Technical Workgroup Meeting Water Resources Studies

Geomorphology Presentation

October 23, 2012

Prepared by: **Tetra Tech and URS**

STUDY INTERDEPENDENCIES FOR THE GEOMORPHOLOGY STUDY

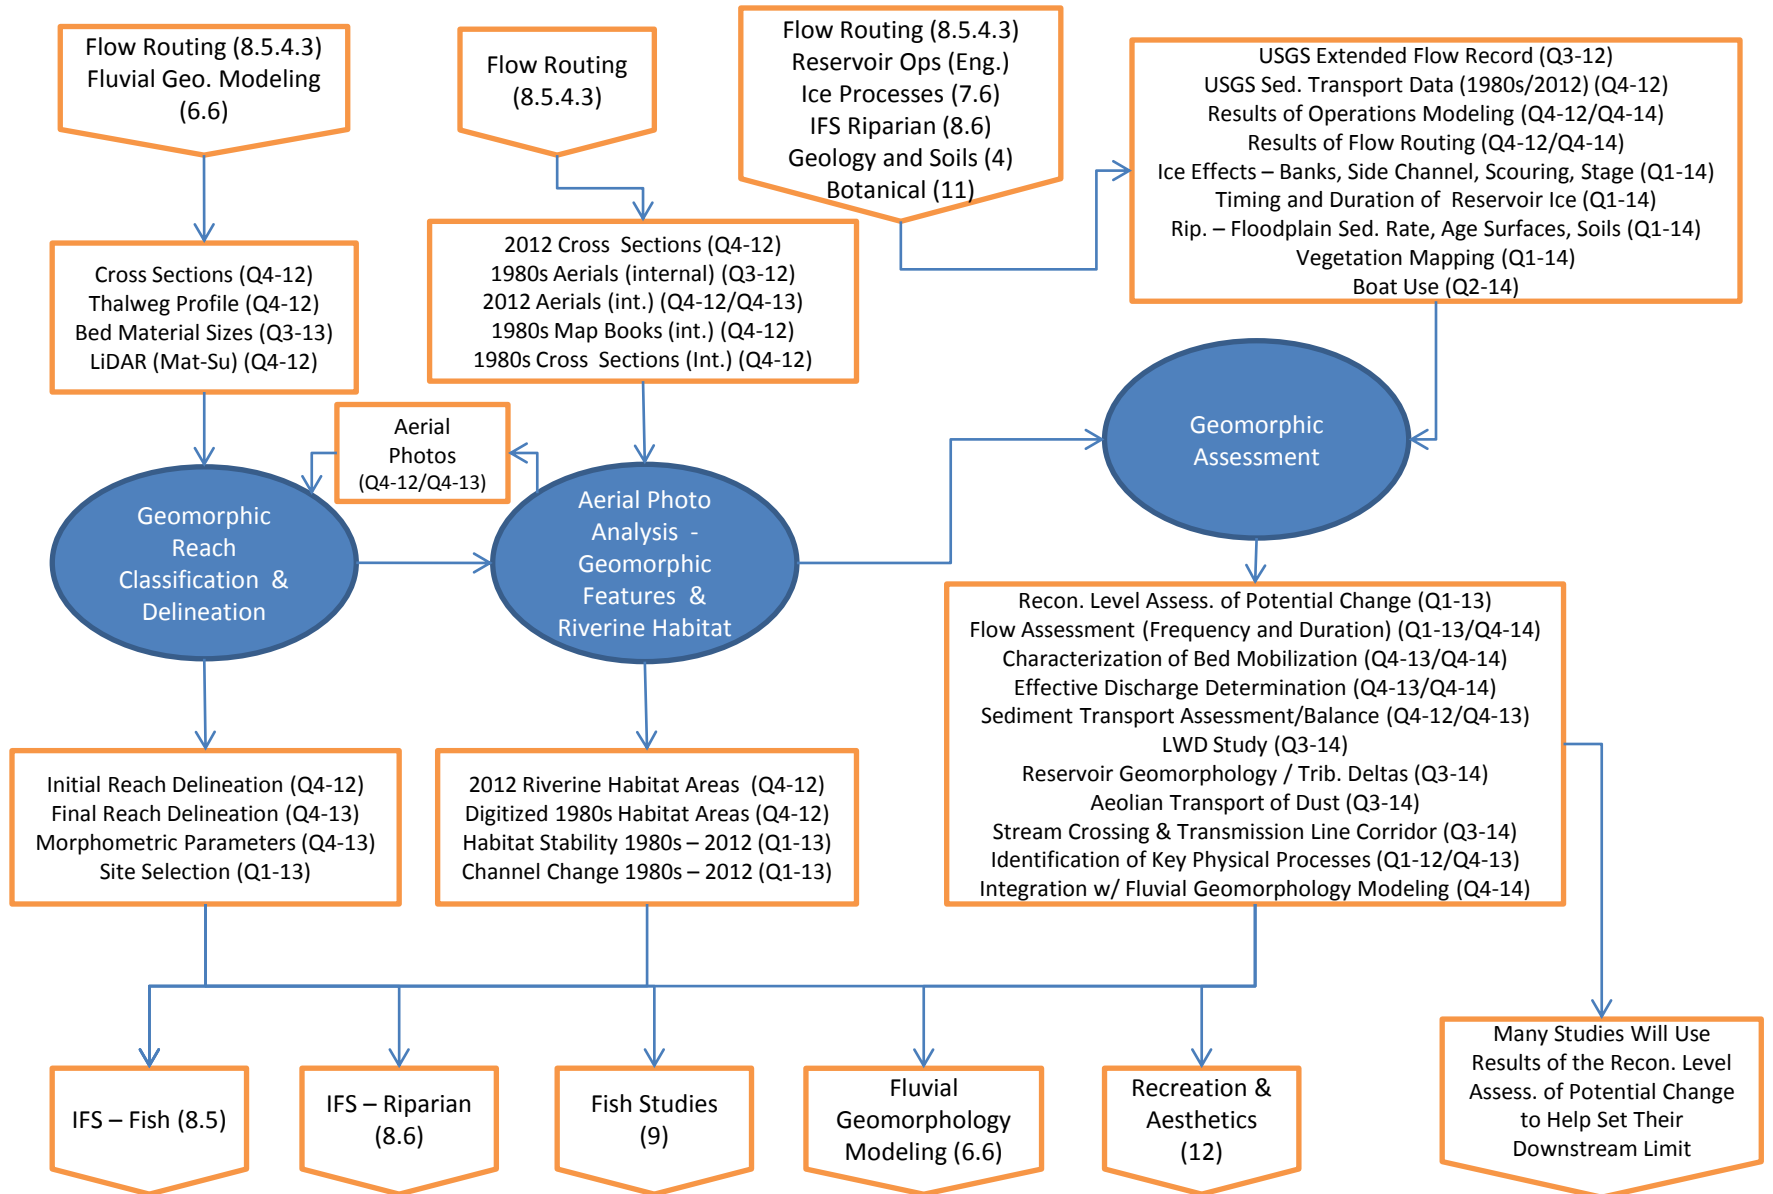
USFWS Comment: Instream Flow, Habitat Utilization, Geomorphology PSPs do not fully address USFWS' resource mgmt. concerns. During 3 days of ILP study meetings, sequencing and integration of proposed biological resource studies and physical processes was not described; significant outstanding info needed.

Source: RSP Sections 6.5.6 Schedule (Geomorphology Study) and 6.6.6 Schedule (Fluvial Geomorphology Modeling Study).

Additional information in 6.6.4.1.2.2

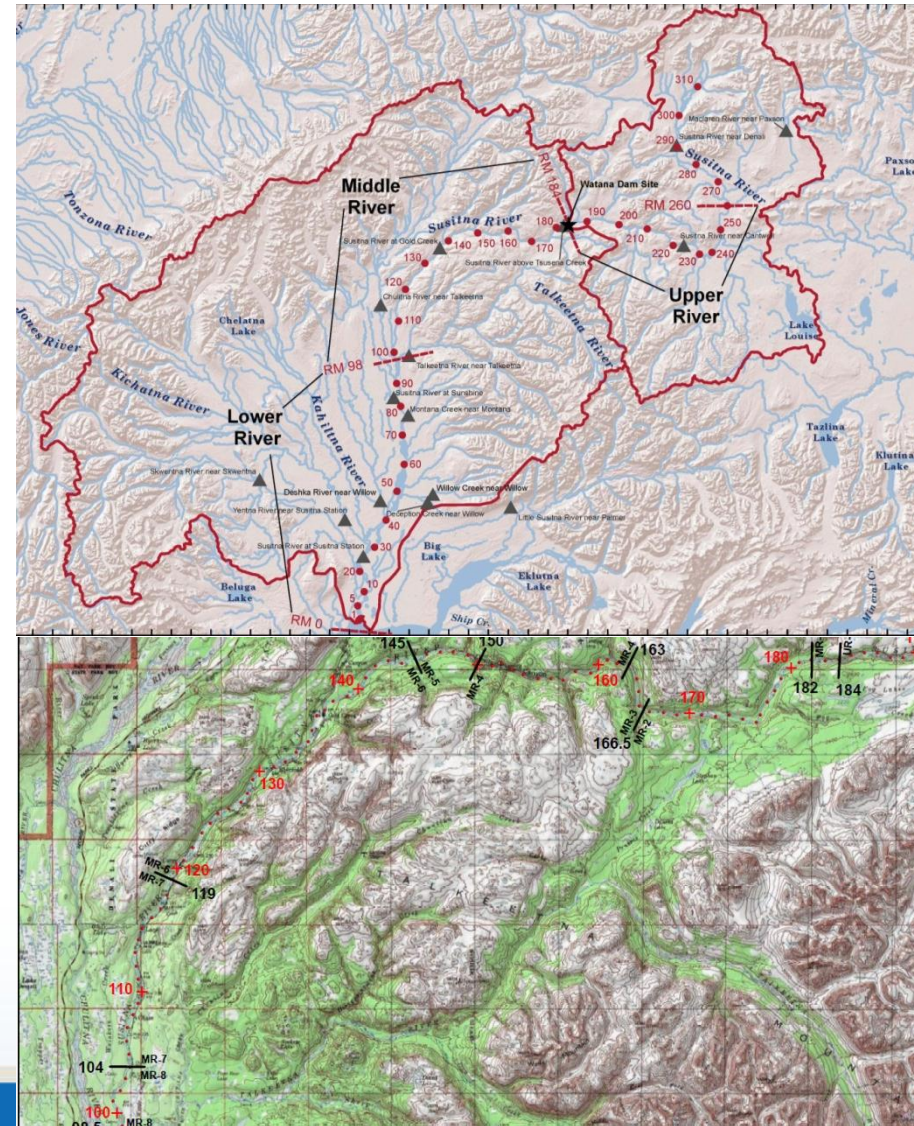
Stillwater FERC Comment: It would be useful to further define the stratification system on a local & reach scale.

USFWS Comment: The Service specifically requested hierarchically nested habitat mapping (e.g., Frissell et al, 1986).

Source: First two levels of the stratification system are described in Section 6.5.4.1 of the Geomorphology Study. The remaining three levels are described in the Study 9 Fish and Aquatic Resources

1. Segments
2. Geomorphic Reaches
3. Mainstem Habitats (Main Channel & Lateral)
4. Main Channel Mesohabitat (Pool / Riffle / Run)
5. Edge Habitat Length

2012 Susitna River Aerials RM 98.5 to RM 61

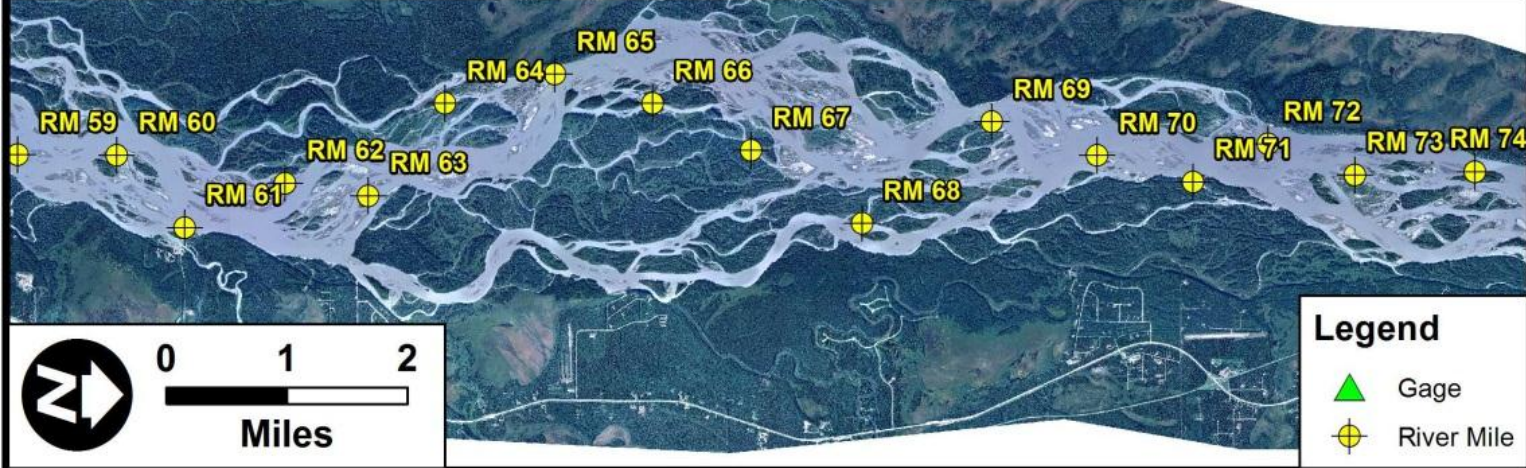
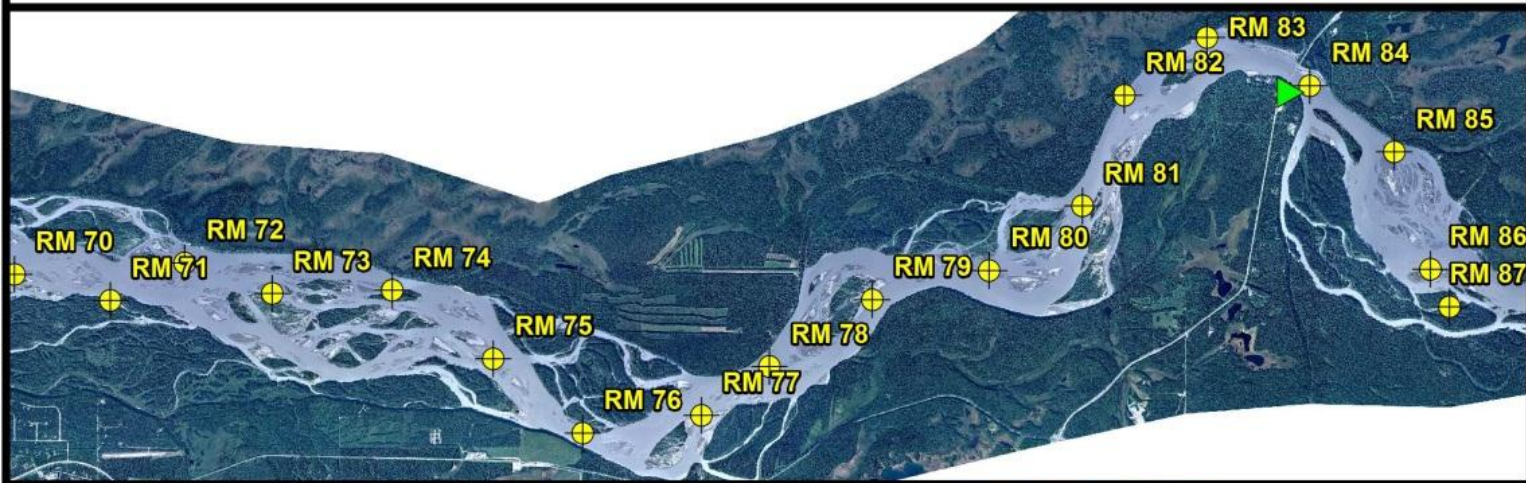
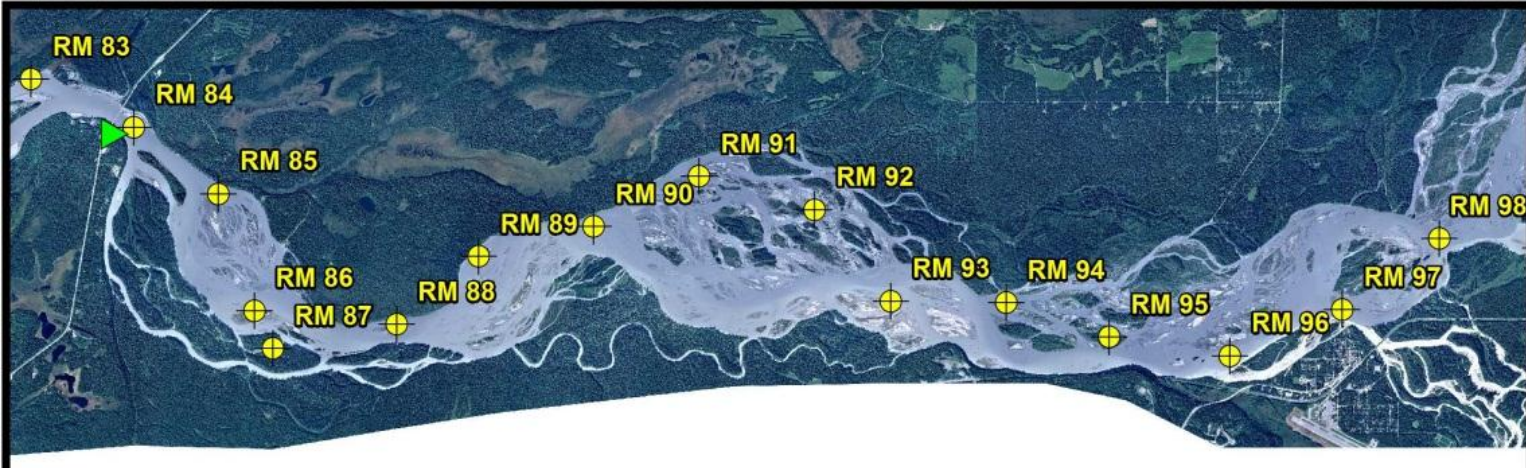
USFWS/FERC Staff Comment: What is it, how and when will it be determined. Would it be in the ISR if not reached in RSP? Each study needs to identify the D/S extent and put a mechanism in place to modify the boundaries if needed.

Source: RSP Section 6.6.3.2 Determination of Downstream Study Limit provides a discussion of the initially identified downstream study limit of the Geomorphology Study and describes the process, schedule and criteria for the collaborative effort to finalize and reevaluate the limit as study information is produced.

Downstream limit will be determined in collaboration with the TWG following a process, criteria and schedule

- RM 75 D/S geomorphology modeling limit in RSP (Dec 2012)
- Reconnaissance level assessment of Project effects and flow routing model results (Jan 2013)
- Tech memo on reconnaissance level assessment of Project effects in Lower River (Jan 2013)
- TWG meeting for confirmation of D/S geomorphology modeling limit (Feb/Mar 2013)
- 1D modeling and 2013 Geomorphology Study results and tech memo (Jan 2014)
- TWG meetings to reevaluate/confirm D/S limit (Feb/Mar 2014)
- Collect additional data if need identified (Summer 2014)

1D Modeling Cross Sections

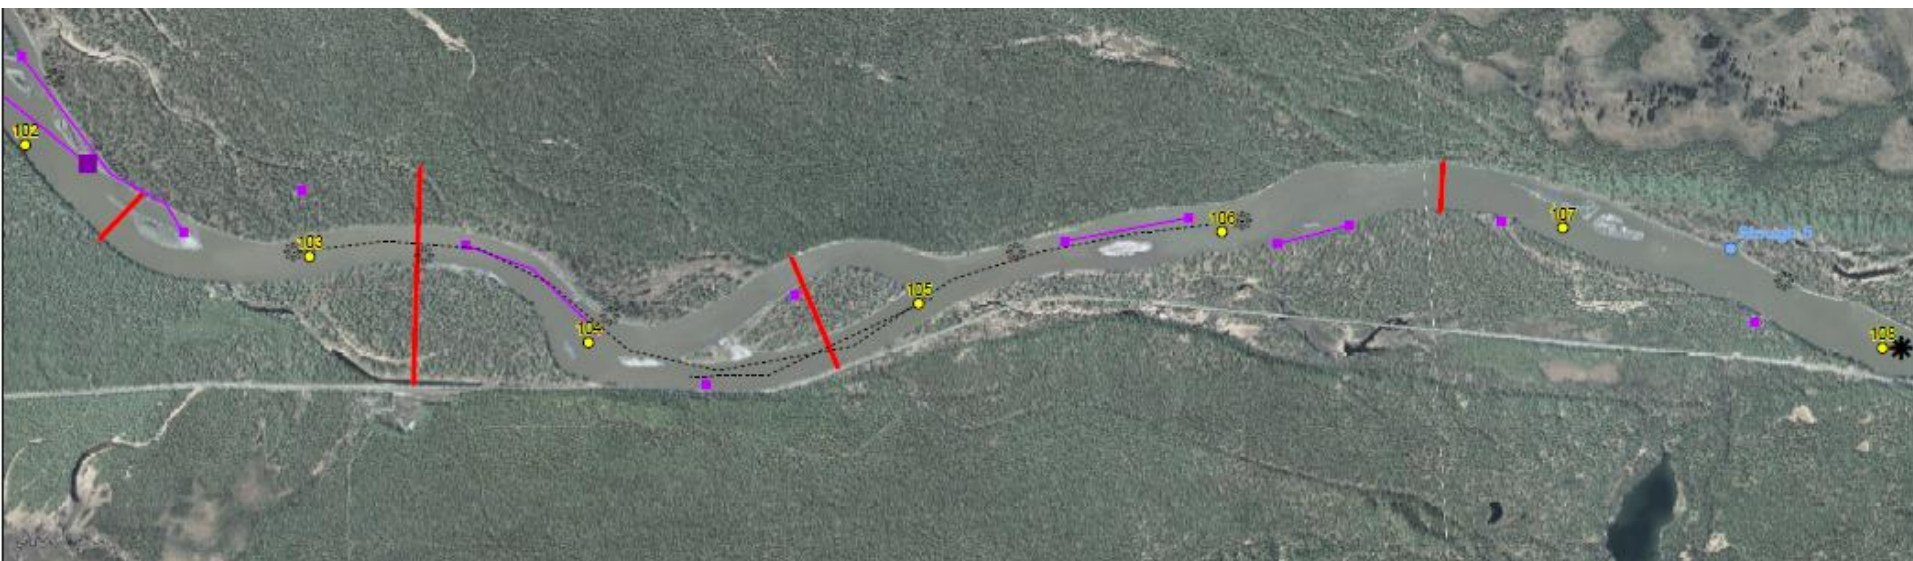
NMFS Comment: Will additional cross section be selected at areas that aren't hydraulic controls and added to the 1D model? This question was brought up since the hydraulic routing model data collection likely concentrated on hydraulic controls, but these may not be the best features for describing sediment transport processes.

Source: RSP Section 6.6.4.1.2.8 describes the collection of additional cross sections in 2013 to support the 1D bed evolution model development.

Whiskers Creek Site - Fine Mesh

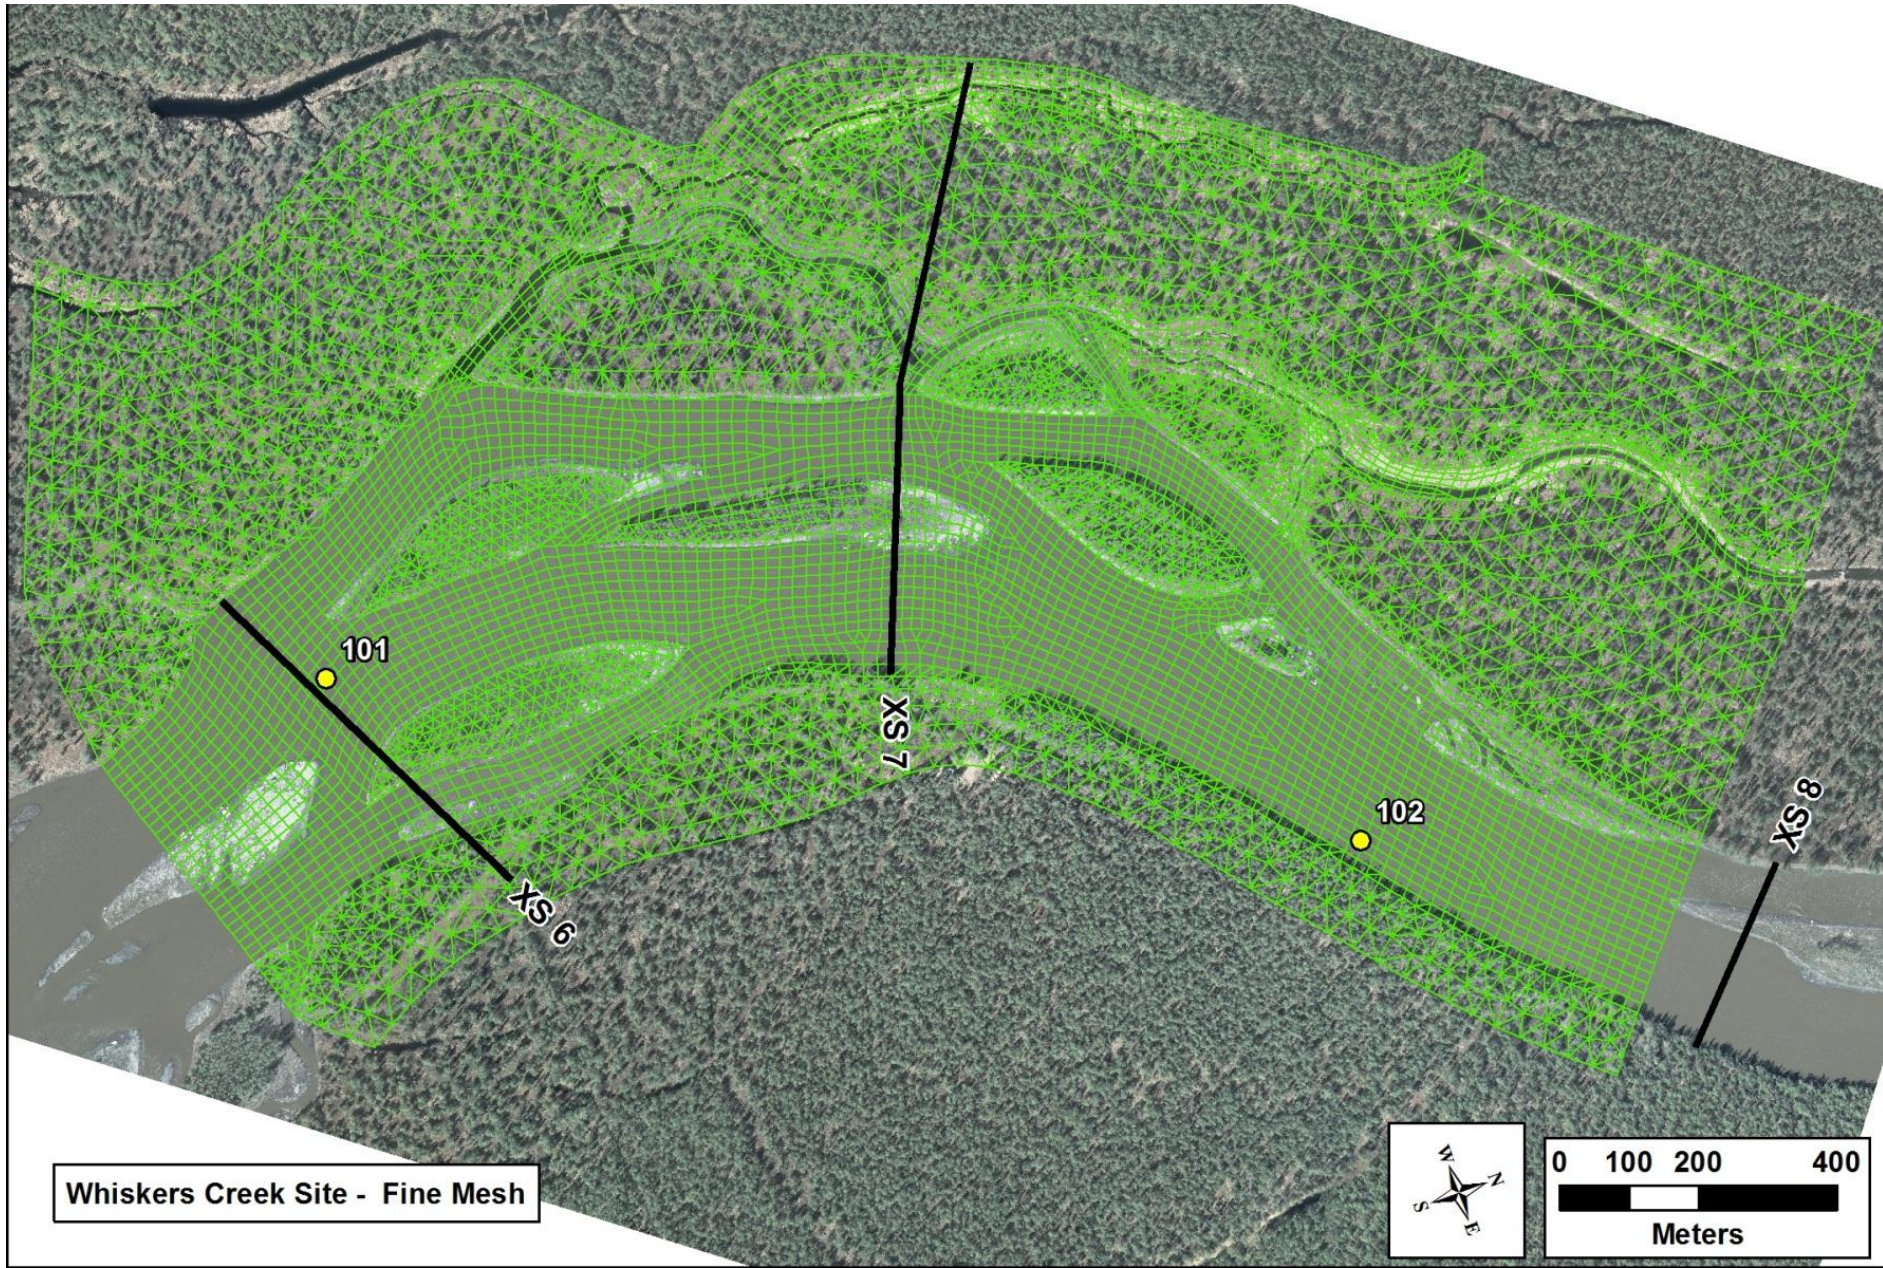
- **USFWS, ARRI, ADNR, ADF&G Comment:**
General discussion on the mesh size for the 2D model with questions concerning: what will the size be? Will field results influence it? When will size be selected? Will 2D modeling include side channels and sloughs within study area?

Source: RSP Section 6.6.4.1.2.3 Model Resolution and Mesh Size Considerations has been added to provide the requested information.
